**Project:** 4J Security Improvements Projects (2207)  
**Title:** Addendum No. 003  
**Date:** April 7, 2023  
**From:** KC Eck, PIVOT Architecture  
**To:** Interested Bidders

1. This Addendum is in response to Bidder questions and some revisions made during the bid walk through.

A03-B

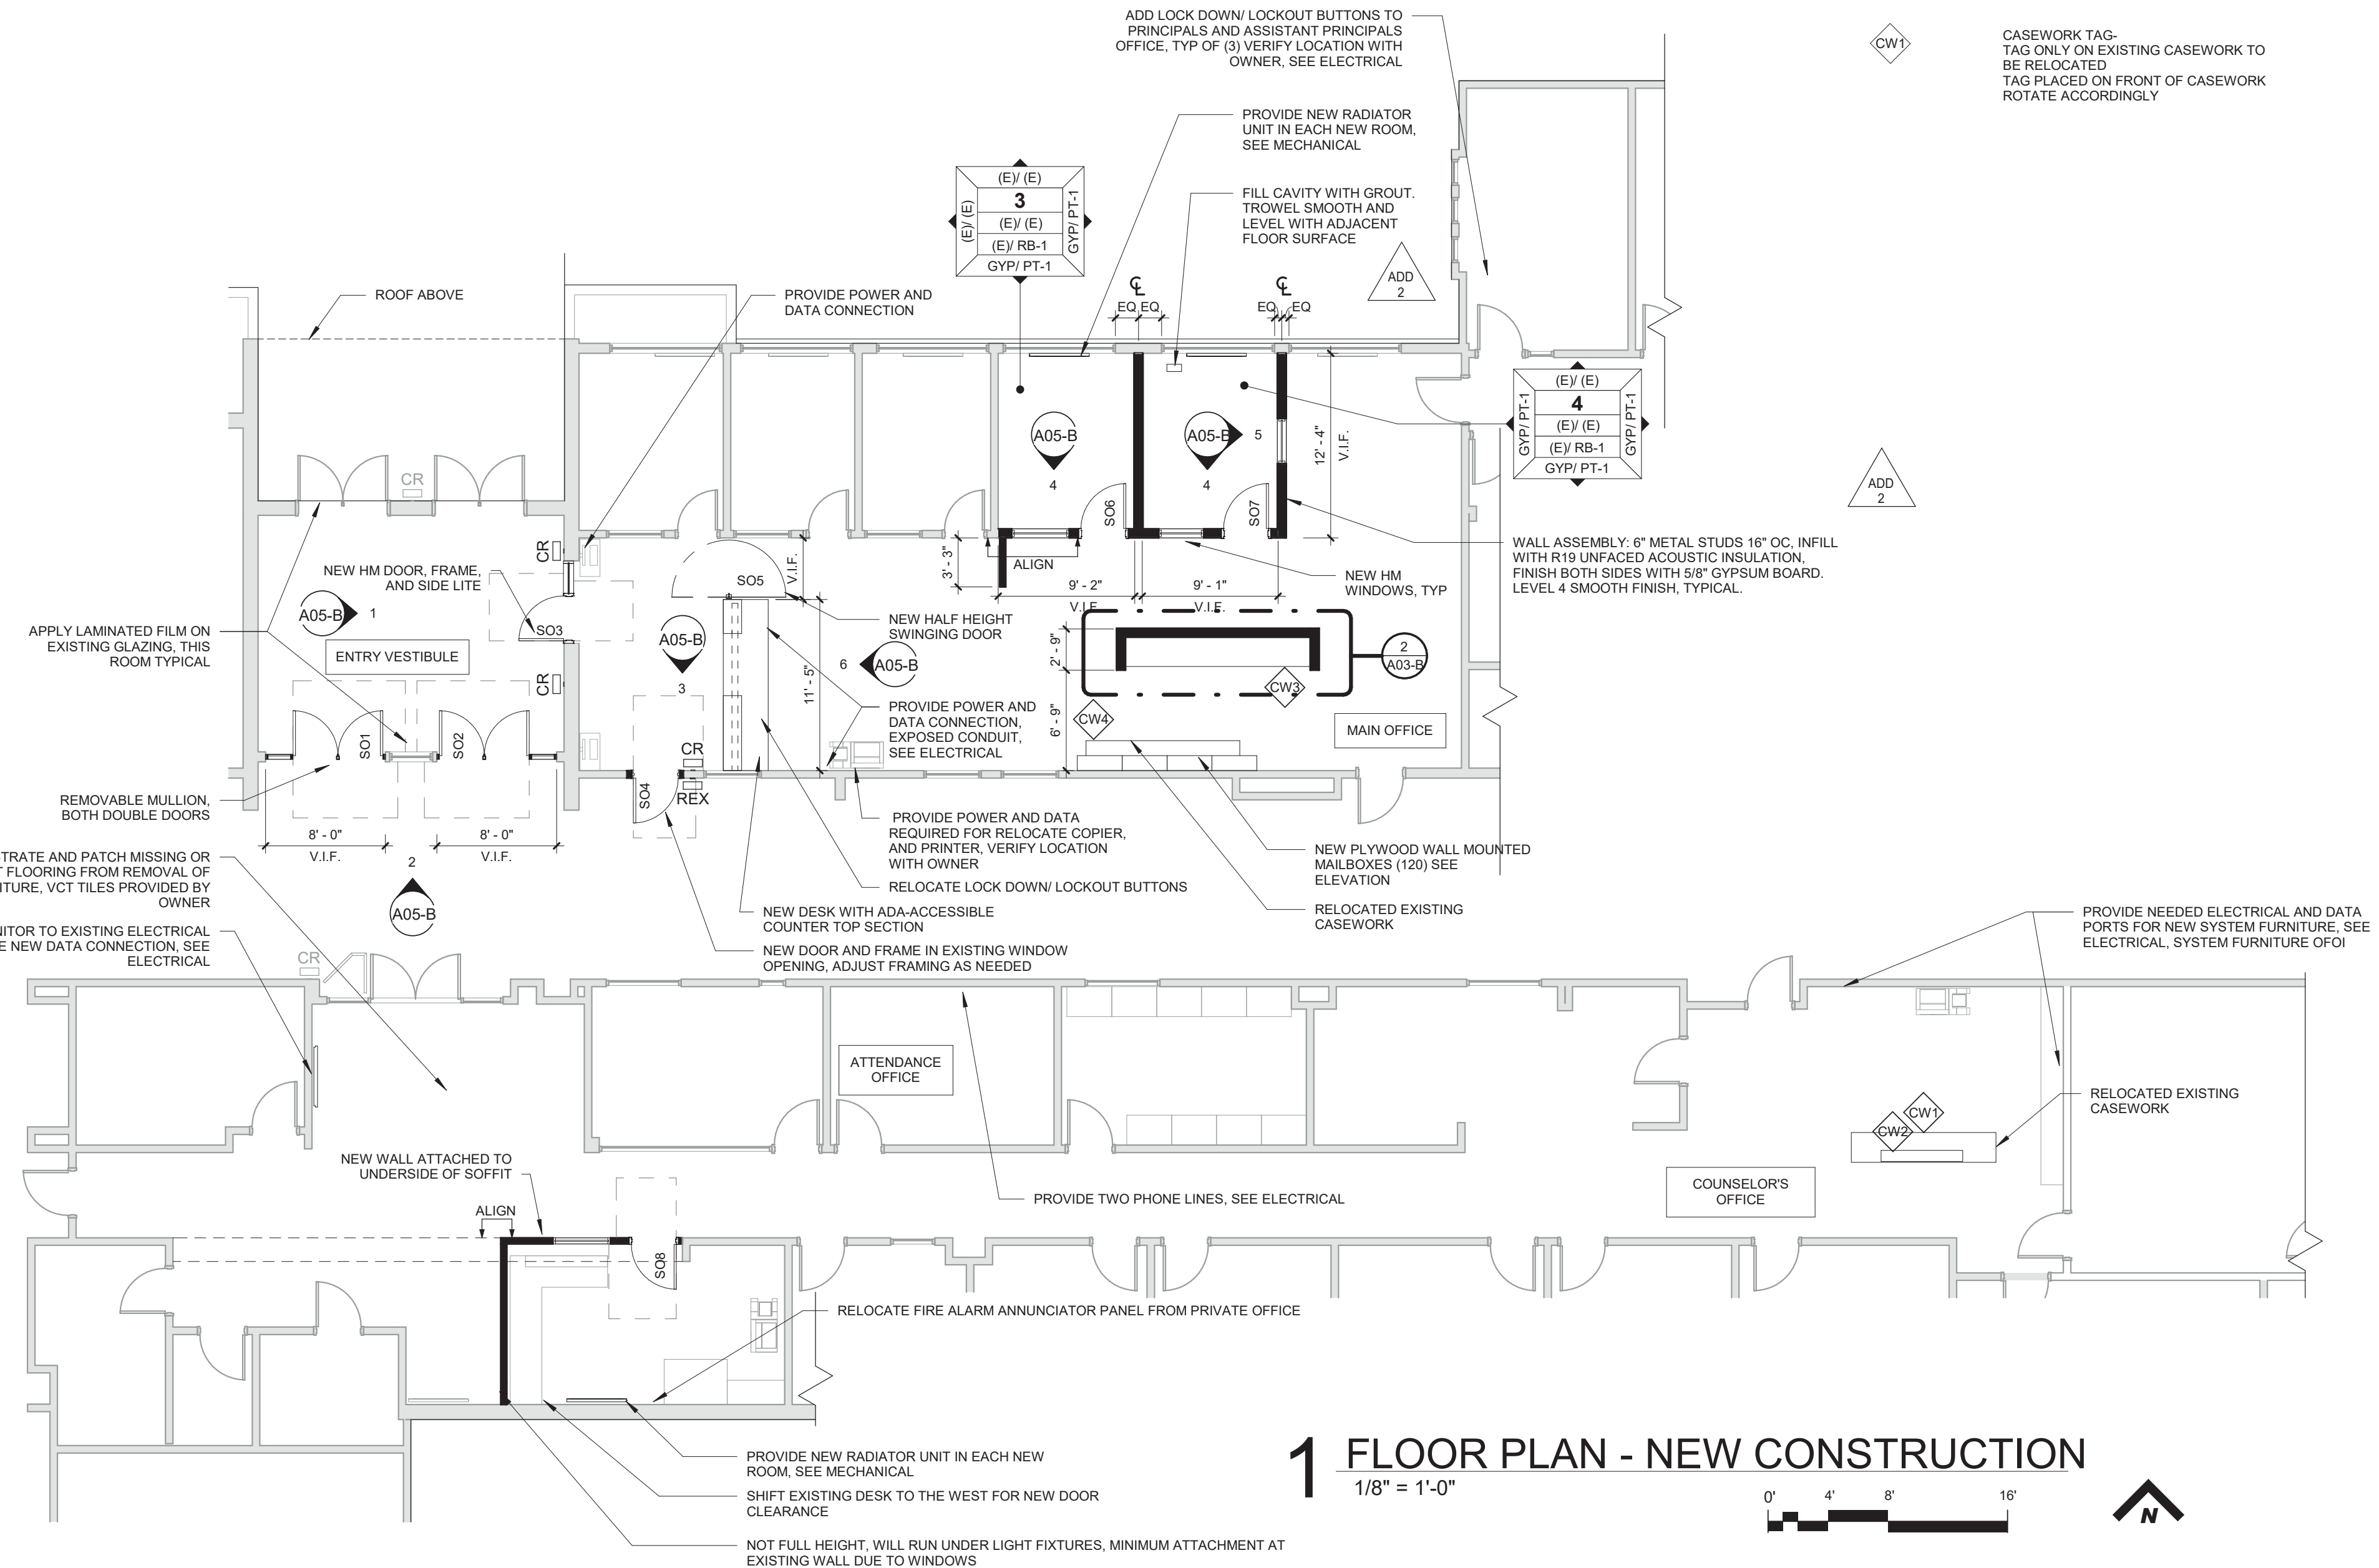
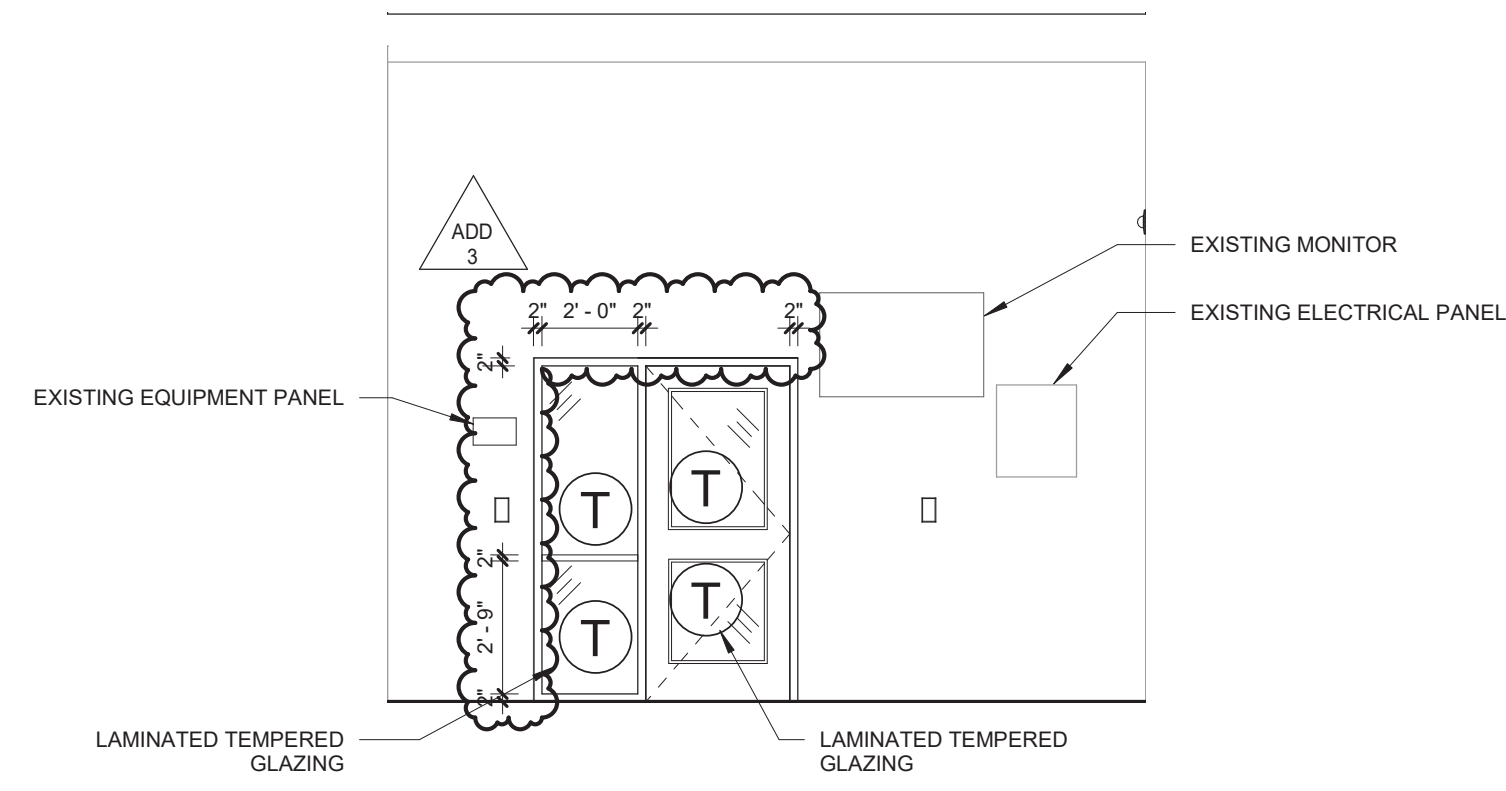
3. Opening S03 on the door schedule is showing a width of 5'2". Also showing that the opening has a relite. Same question, is the 5'2" the door size or the out to out of the frame?  
*5'-2" is the frame size, see revised sheets A03-B and A05-B*
